CITY OF ALBUQUERQUE

Re: TEF Warehouse
10116 Cochiti Rd. NE
Traffic Circulation Layout
Engineer's/Architect's Stamp **6-9-16** (L20-D069)

Figure 1. Mini Clear Sight Triangle

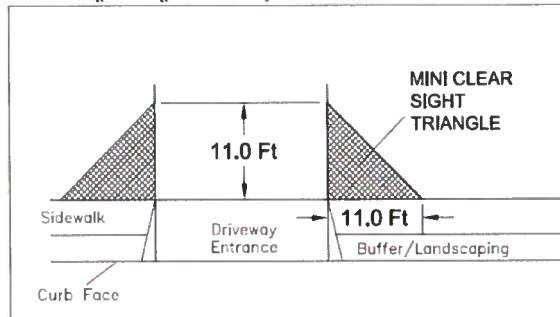
Mini Clear Sight Triangle for Driveways on Residential Streets:

9. Please add the following note to the clear sight triangle: "Landscaping and signage will not interfere with clear sight requirements. Therefore, signs, walls, trees, and shrubbery between 3 and 8 feet tall (as measured from the gutter pan) will not be acceptable in this area."
10. Unused curb cuts must be replaced with sidewalk and curb & gutter. A build note must be provided referring to the appropriate City Standard drawing.
11. All broken or cracked sidewalk must be replaced with sidewalk and curb & gutter. A build note must be provided referring to the appropriate City Standard drawing.
12. Please include two copies of the traffic circulation layout at the next submittal.
